Some remarks on XFEL tunnel racks containers prototypes at first look

Both prototypes are 3 racks type and should fulfill the racks specification made by Kay Rehlich (“Spezifikation der Schränke für den XFEL”---Tunnel Version 1.4, 24.11.2010, Kay Rehlich, DESY, MCS4).

Fig. 1. Rittal 3 racks container prototype front view.

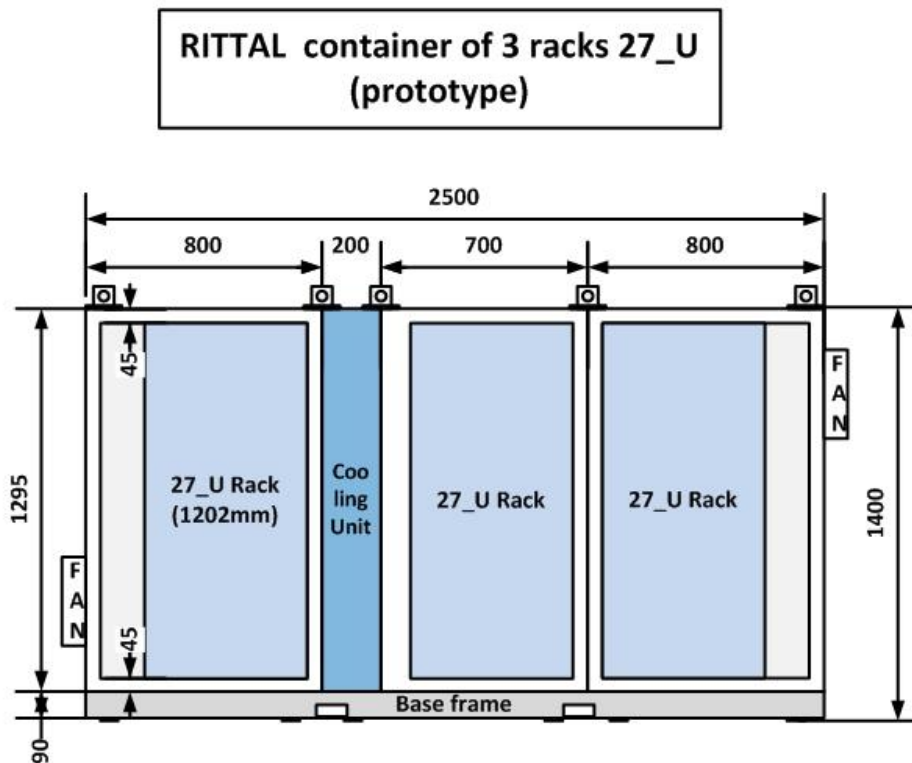
Rittal prototype, assuming remove of crane ears from top, fits to the required height to be maximum of 1400 mm, but exceeds a little bit a width (to be maximum of 2500 mm). The container width is 2500 mm (as specified), but emergency fans 'covers' exceeds this dimension by ~30 mm each. There is enough space inside a container to hide emergency fans deeper inside.

Fig. 2. Schroff 3 racks container prototype front view.

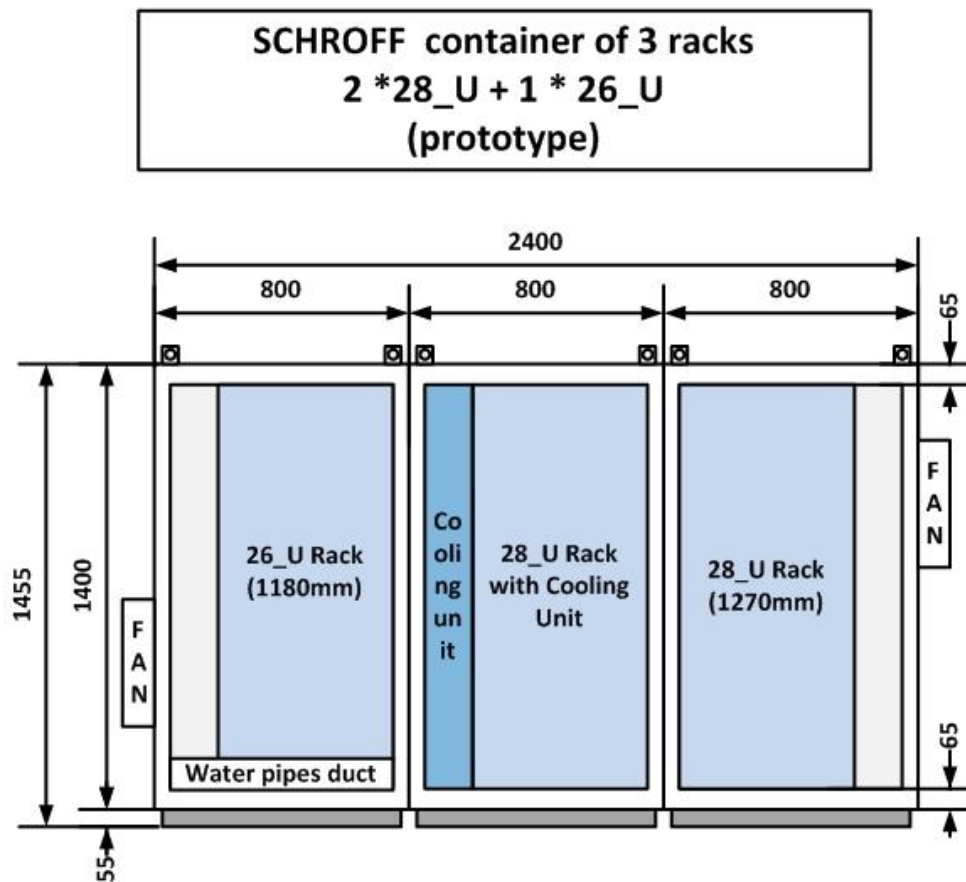
Schroff prototype does not fit to the specified height (to be maximum of 1400 mm) and is 1455 mm (assuming remove of crane ears from top). The width of container is 2400 mm and even with emergency fans 'covers' fits to the specification.
